### Village of Summit Plan Commission Thursday, November 20, 2025, 5:30 p.m. At the Summit Village Hall, 37100 Delafield Road

**Bryant & Emma Nelson – Special Exception  
Vertical Addition to Residence within Offset  
34845 Elm Street (SUMT0670049)  
11/20/2025 Plan Commission Meeting**

**White Stone Community Church**  
**2517 N. Dousman Road (SUMT0637999008)**  
11/20/2025 Plan Commission Meeting

**LOEPFE CERTIFIED SURVEY MAP REVIEW**  
**11/20/2025 Plan Commission Meeting**  
**Lola and Bob Loepfe**

**PRELIMINARY SURVEY**

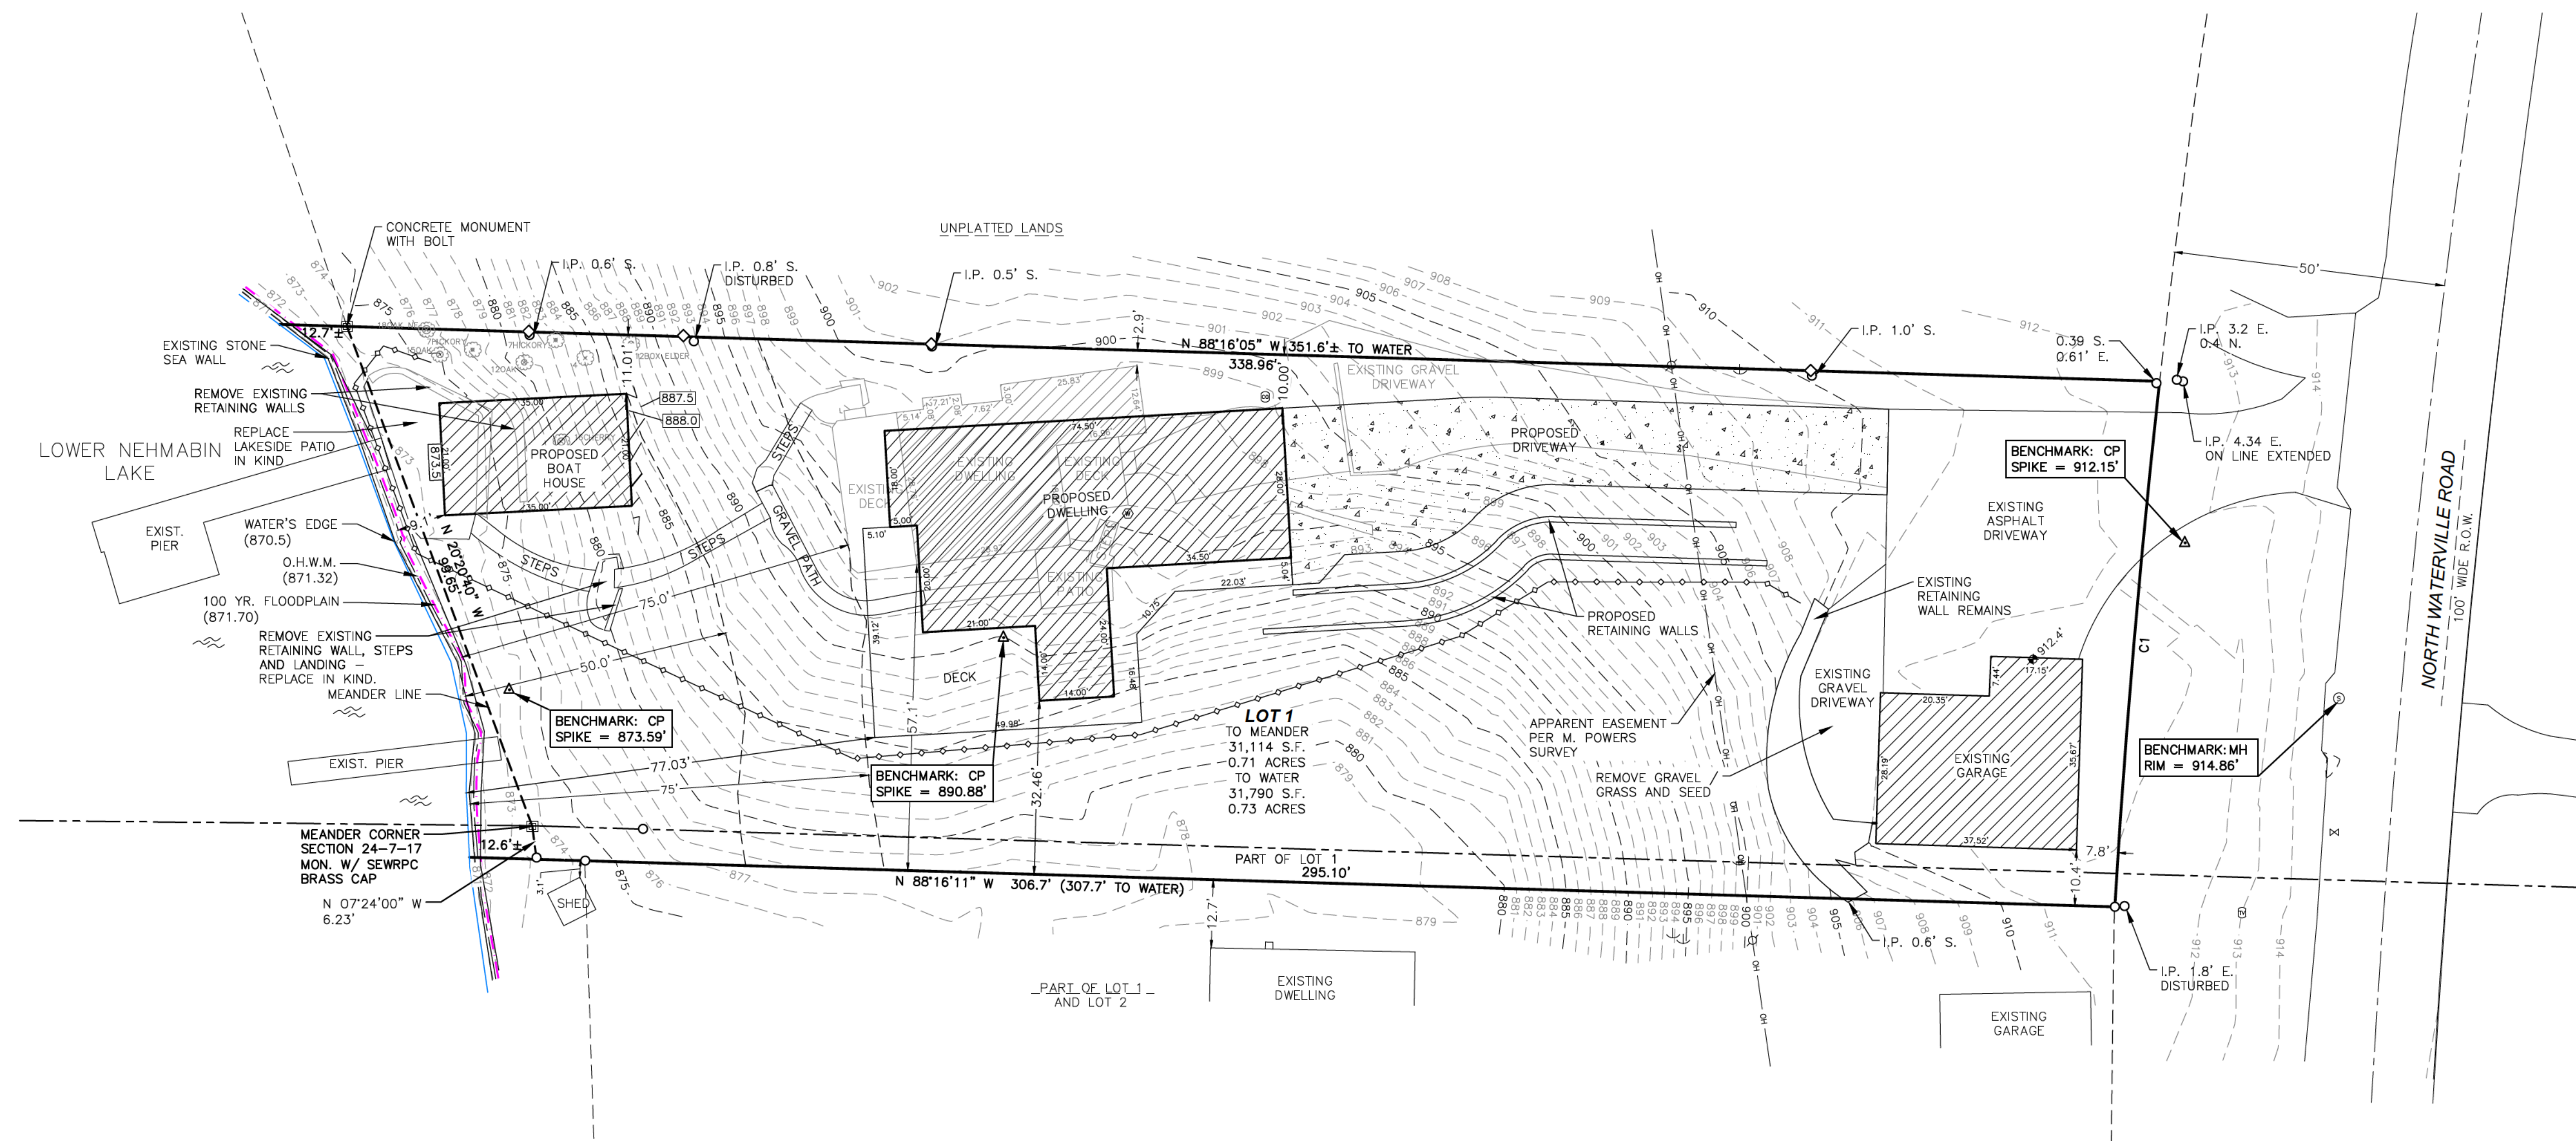
The applicant obtained previous permits for the construction of a detached garage and retaining wall. The plans for the permitted retaining wall indicated that it would be 5-6 ft. from the lot line, 5-10 ft. from the west side of the garage, 3-6 ft. in height, and 30-45 ft. in length. Staff was later notified that the applicant constructed a retaining wall that exceeded the plans provided for the permit.

The applicant was notified of the violation and has submitted plans for after-the-fact approval. The wall is approximately 15-20 ft. from the west side of the garage at the widest point, 60 ft. in length, and located over the south lot line by six inches, although only 12 inches in height at that location. The wall varies significantly in height with the highest portion being approximately 6.3 ft. in height.

Section 111-73(c) Preservation of topography states that the zoning administrator may issue a permit for a retaining wall greater than five feet from the property line. The plan commission may otherwise direct the zoning administrator to issue a permit for a retaining wall located five feet or less from a property line, following a public hearing. The retaining wall shall not adversely affect surrounding land. Based on a site inspection, the retaining wall does not cause adverse drainage on adjacent properties and the adjacent property to the south supports the construction of the wall. The wall is located approximately 40 ft. from the north lot line. Drainage from the retaining wall is directed toward the southwest, and not directed to the north.

**SHEET**  
**C2.0**

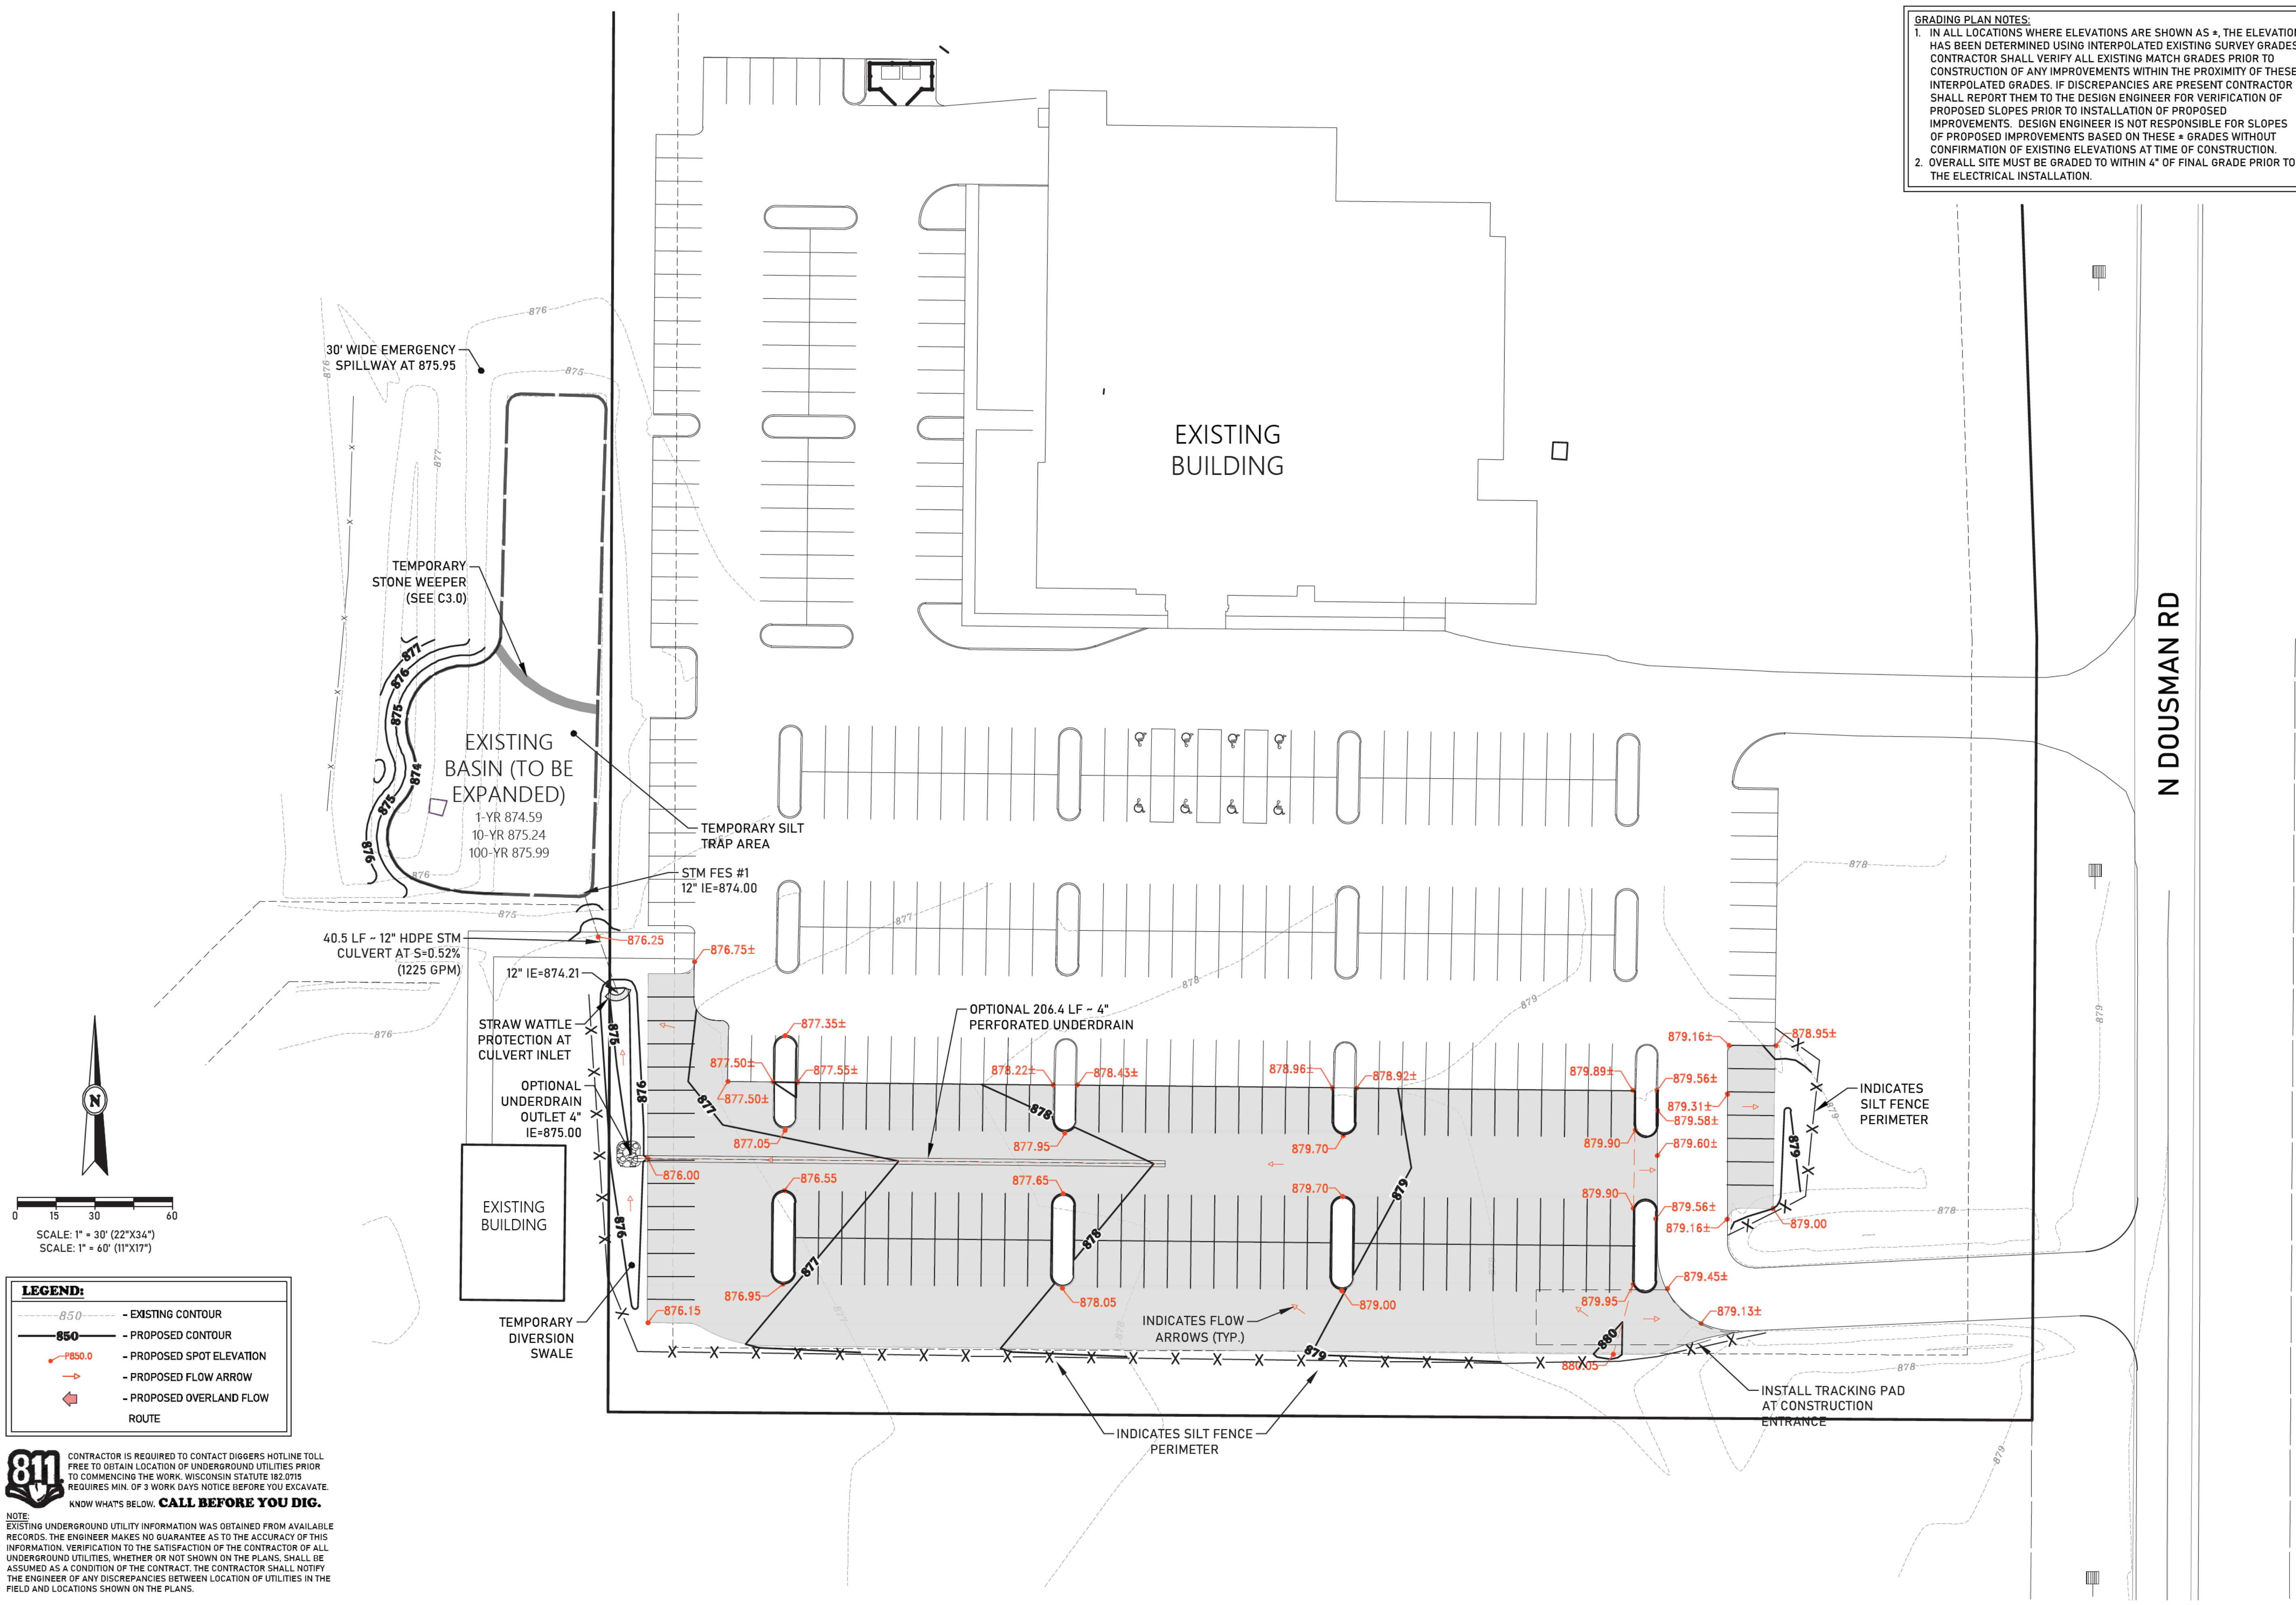
1. Pre-treatment of the expanded lot runoff needs to be provided. WinSLAMM modeling, or DNR guidance for pretreatment, need to be used to show adequate measures for a parking lot land use.
2. As-built information for the recently constructed storm water basin should be used for modeling of the expanded basin.
3. An exhibit should be provided, using actual field information for the newly constructed parking lot and storm water facility, that accurately shows the curb and pavement grades. This exhibit is needed to verify if parking lot inundation is occurring for both the 100-year event, as well as the 100-year frozen conditions.

5. It is not clear that the proposed emergency spillway is able to positively drain. More topographic information is needed. Our review of the GIS topography questions whether this can be achieved. Our recommendation is to investigate a swale draining to the north and into the northerly basin, which has a positive emergency overflow route further to the north.
6. The proposed emergency overflow and 100-year calculated water surface elevation appears to pond water into the parking lot and should be revised to remove this ponding by expanding the volume of the basin and/or lowering the spillway.

7. The pre-treatment bio-swale proposed for the phase 1 storm water management facility is not shown on the plans. As noted above, pre-treatment is needed prior to infiltration and needs to be incorporated into the storm water management and civil plans.
8. The SWMP addresses and accounts for storage from apparently existing swales to the southwest. These should be shown on the plan and more clearly show how the basins are interconnected and how runoff is being directed to them.
9. The 12-inch CMP proposed for the sidewalk to the accessory building is likely undersized and may back up runoff where it is not intended. Provide culvert sizing calculations and the floor elevation of the existing adjacent structure to insure the water levels remains below and doesn't impact it or the parking lot.

10. The as-built plans for the previous phase of expansion have not been received yet.. The new expanded area should be based on actual field information. Any modifications needed will need to be included with the expansion work and an updated as-built plan provided that includes the entire system. The basin as-built needs to include the west edge of the parking lot to verify that the lot is built above the overflow and/or determine the extents of potential lot flooding during large events.
11. A Village SW & EC permit is required. The form can be found on the Village's website.
12. A pre-construction meeting with the Village Engineer is required prior to starting any land disturbance activity.

- 1. All conditions of the Village Engineer letter dated November 12, 2025 shall be complied with. The Engineer's recommendation related to the placement of wheel stops or curb shall be complied with.*
- 2. A revised landscape plan shall be submitted for review and approval by Village Staff. The plans shall comply with all ordinance requirements.*
- 3. A revised lighting plan shall be submitted for review and approval by Village Staff. The plans shall indicate the location of all existing and proposed light poles. The photometrics shall include the lot lines. Light trespass shall be limited.*
- 4. The Fire Department shall review the plans to ensure access and maneuverability.*
- 5. The applicant shall demonstrate that they meet the maximum 50% impervious surface requirement of the IN Institutional District.*
